Access Compliance Report

Public Rights-of-Way

(Curb Ramps)

Intersection ID: 54460	Main Street: STEELE_MEADOW_RD	Cross Street: FLINT_HILL_DR	Location: NE
ADA ID: 80C834204B77	Ramp Type: Perp	Initial Pass/Fail: Fail	Overall Compliance: No
Severity Score: 21.25			
Codes/Mitigation Info/Possible Solution		Field Measurements/Component Compliance

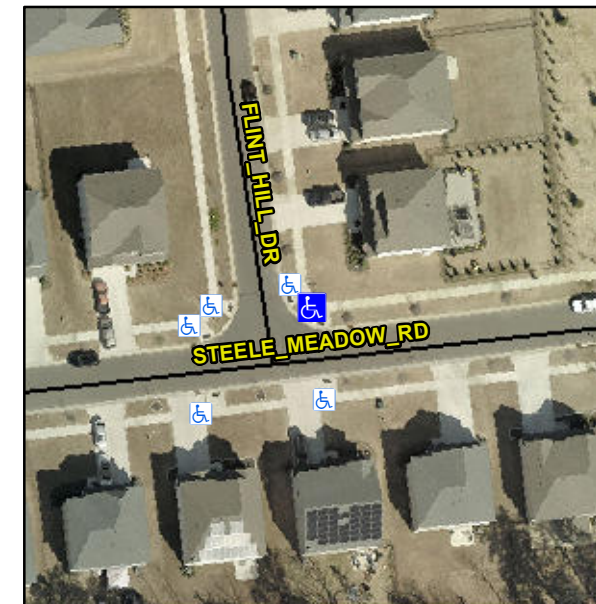
R304.5.1, R304.2.2

Compliance	Description	Data	Compliance	Description	Data
N/A	Ramp Length (in)	97.0	No	Ramp Slope (%)	9.3
No	Ramp Width (in)	46.0	Yes	Ramp XSlope (%)	1.2
N/A	Flare Type LT	N/A	N/A	Flare Type RT	N/A
N/A	Flare Slope LT (%)	N/A	N/A	Flare Slope RT (%)	N/A
N/A	Flare Traversable LT?	N/A	N/A	Flare Traversable RT?	N/A
N/A	Landing Length (in)	N/A	N/A	DWS Provided?	N/A
N/A	Landing Width (in)	N/A	N/A	DWS Contrast?	N/A
N/A	Landing Slope (%)	N/A	N/A	DWS Length (in)	N/A
N/A	Landing X Slope (%)	N/A	N/A	DWS Full Width?	N/A
N/A	Landing Curb? (Y/N)	N/A	N/A	DWS Offset (in)	N/A
N/A	Shared Landing?	N/A			
N/A	Gutter Ponding?	N/A	N/A	Gutter Slope (%)	N/A
N/A	Gutter Lip Ht (in)	1.0	N/A	Gutter X Slope (%)	N/A
N/A	Painted X Walk1?	No	N/A	Painted X Walk2?	N/A
	X Walk 1 Direction	To S		X Walk 2 Direction	N/A
N/A	X Walk 1 Width (in)	N/A	N/A	X Walk 2 Width (in)	N/A
	X Walk 1 Slope (%)	1.5		X Walk 2 Slope (%)	N/A
	X Walk 1 X Slope (%)	2.1		X Walk 2 X Slope (%)	N/A

Remove & Replace Entire Ramp.
